#### Changes in RSS Calculation Methods

Hatfield & Dawson Consulting Engineers, LLC

**FIGURE 1**                      ZNS-1 Overlap to KXEL

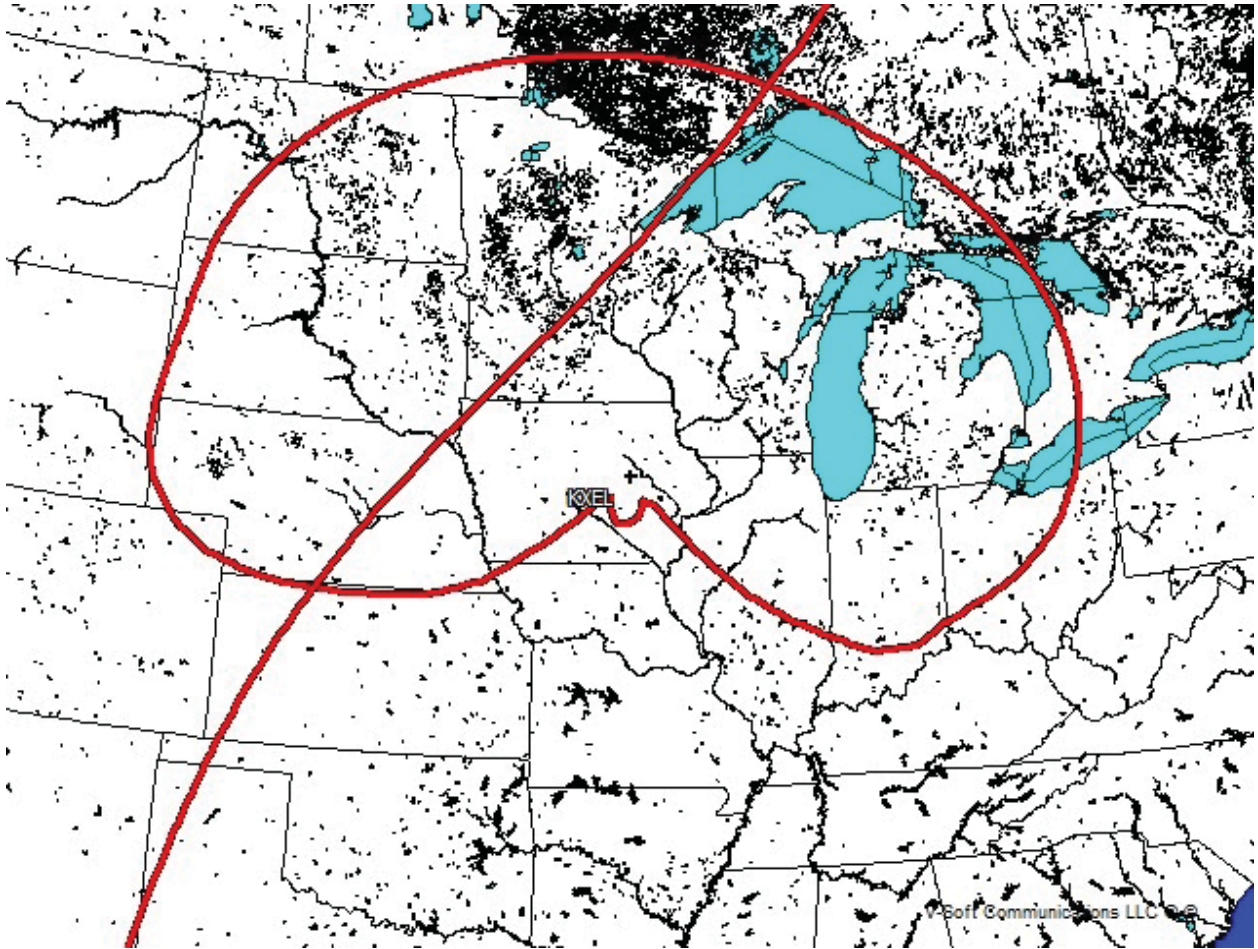
Figures 1 through 7 provide illustrative examples of a variety of these conditions: 25  $\mu$ V/m (10% time) overlap of class A station 0.5 mV/m (50% time) contours on U.S. territory. Based on these and many other instances it is clear that protection of class A station skywave service is at best anachronistic. It just doesn't exist, and its protection in the rules should be eliminated.
